**GREATER WINNIPEG WATER DISTRICT
SECOND BRANCH AQUEDUCT**

TITLE:
**AIR RELEASE VALVE &
VACUUM VALVE CHAMBER**

DRAWING NO. **D-803**

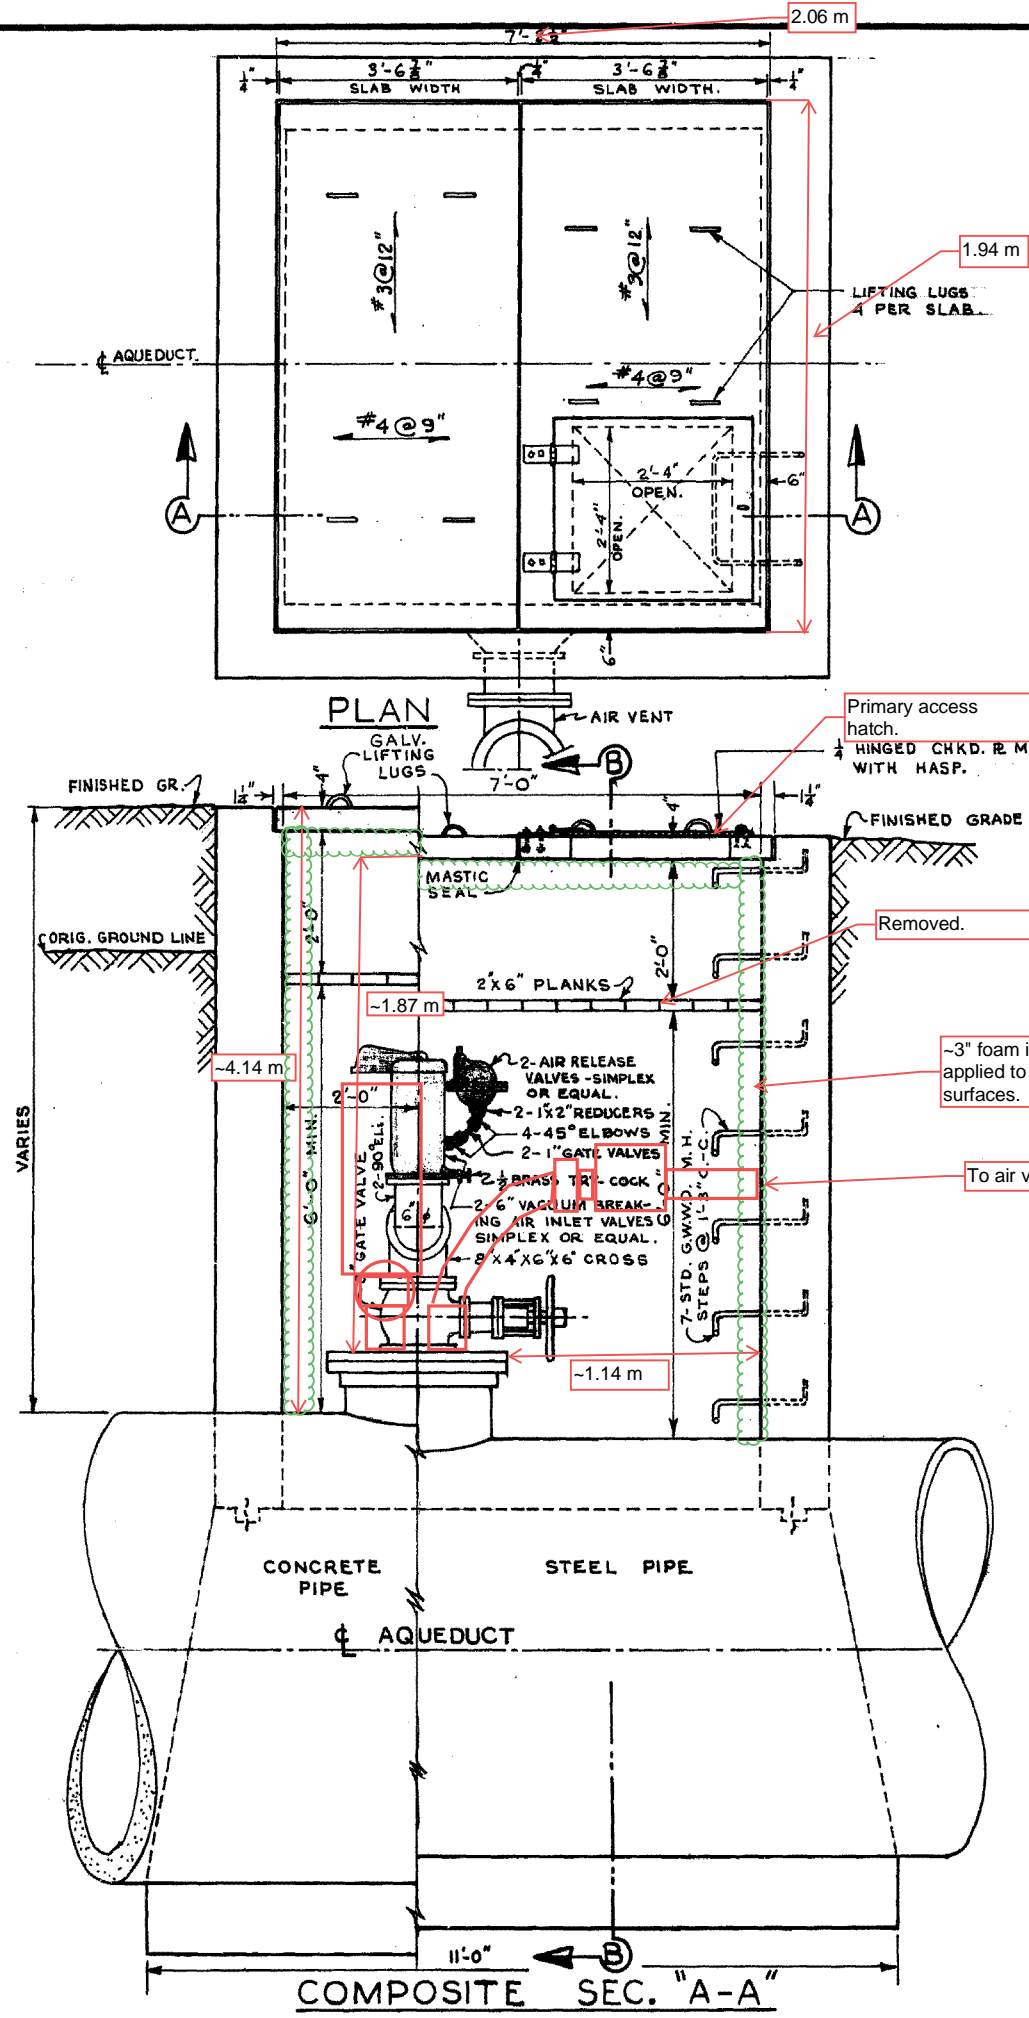
Vent piping not as shown. See Sec A-A for vent connection details.

Removed.

~3" foam insulation applied to all interior surfaces.

Remove blind flange to facilitate tool access. Blind flange approx. centred in chamber at Sec B-B.
